ArevaEPRDCPEm Resource

From: BRYAN Martin (EXTERNAL AREVA) [Martin.Bryan.ext@areva.com]
Sent: Monday, November 22, 2010 7:40 PM
To: Tesfaye, Getachew
Cc: DELANO Karen (AREVA); ROMINE Judy (AREVA); BENNETT Kathy (AREVA); CORNELL Veronica (EXTERNAL AREVA)
Subject: Response to U.S. EPR Design Certification Application RAI No. 354, FSAR Ch. 3, Supplement 13
Attachments: RAI 354 Supplement 13 Response US EPR DC - INTERIM.pdf

Question 03.08.05-22:**Follow-up to RAI 155, Question Nos. 03.08.05-15**

Figure 03.08.05-22-1—Plaxis 3D Model for Basemat Only (Flexible Superstructure)

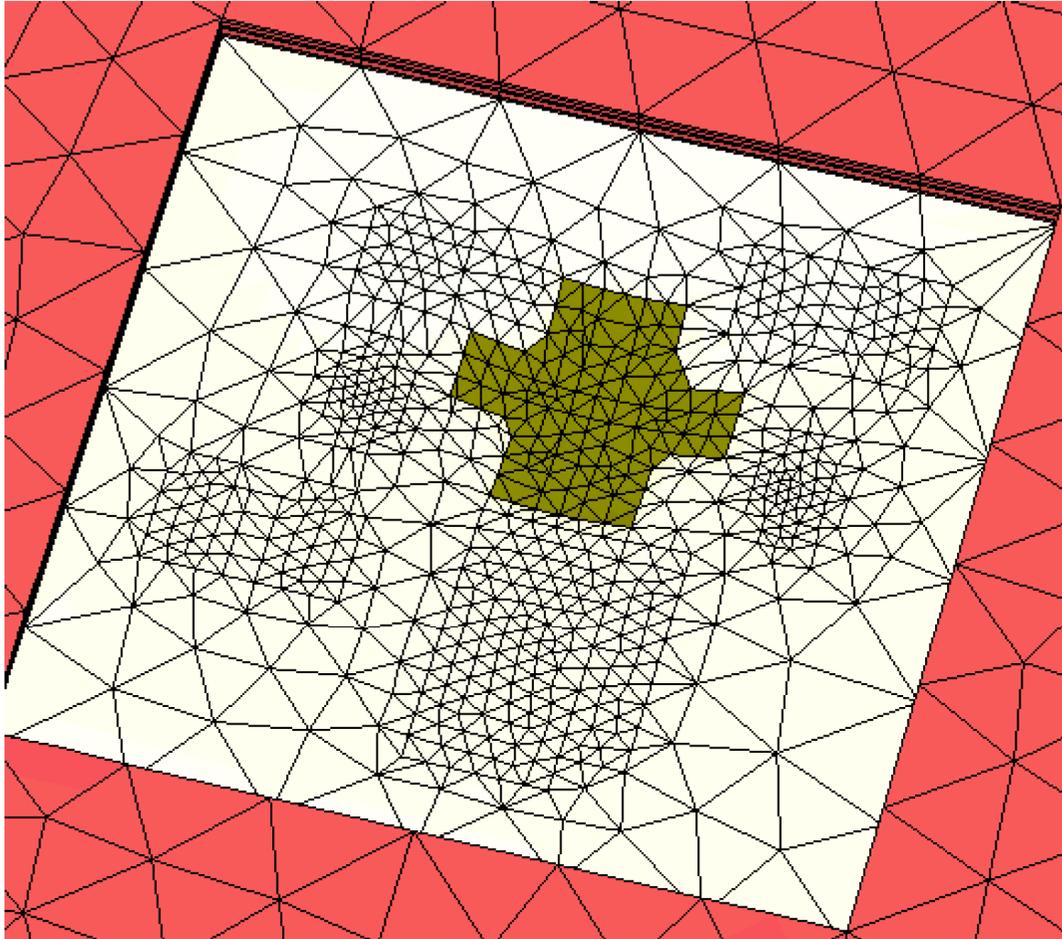
The RAI response, however, implies that there is a construction sequence to be followed during the plant construction. Indeed, the statement that the "largest mass being placed at the center of the basemat early in construction" is equivalent to imposing a sequence on construction, although this is not explicitly stated in the FSAR. Consequently, describe this construction sequence in greater detail (e.g., which structure and to what elevation to be completed in which order), and include this information in the relevant sections of the FSAR so that it can be correctly followed by the COL applicants. In this regard, the staff notes that the purpose of defining a range of sequence of operations is to ensure that segmental cracking will not occur between as-built sections of the facility, particularly for softer soil sites, and that the design of the facility is such as to reduce the need for settlement control during construction.

In addition, as requested in the original RAI, provide details of studies (e.g., models, analysis approach, assumptions, and results) performed to determine the significance of the stresses imposed by the aforementioned construction sequence, as well as the corresponding design implications.

The first set of soil springs is developed using only the basemat loading. The soil spring distribution matches a distribution of the NI common basemat with the full elastic modulus, E_c . The springs are applied to the 3D finite element structural model for each construction step through placement of the slabs at grade elevation. The Plaxis 3D model in Figure 03.08.05-22-1 simulates the foundation with plate elements and is used to develop soil springs for the 3D finite element structural model. The basemat thickness in the Plaxis 3D model is adjusted and soil springs are developed and applied to the 3D finite element structural model until a good fit (less than 10 percent difference) is observed in terms of settlements generated by both the 3D finite element structural model and Plaxis 3D model.

**Figure 03.08.05-22-3—Step 1 - Relative Differential Settlement
(Basemat Only)**

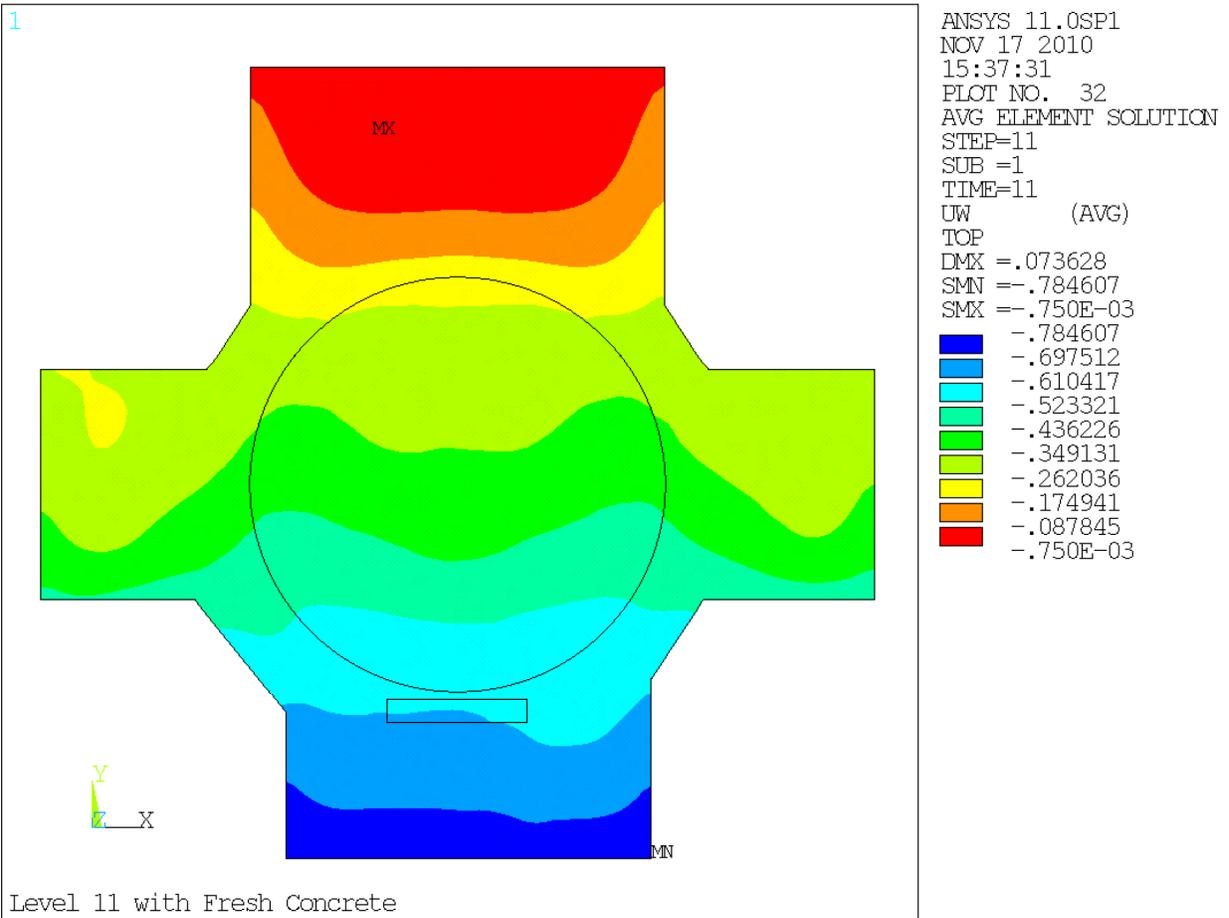
Finally, provide the steps to be taken by the COL applicants whenever measured settlements during construction exceed allowable values. This information should be added to the relevant sections of the FSAR. Also indicate which section of the FSAR sets "differential movement for ... global conditions (3.0 inch differential)" as a limit, and clarify what is meant by this.

4. New figures will be added to U.S. EPR FSAR Tier 2 to show differential settlement contours, and will be included in the revised FSAR in the final response to this question.
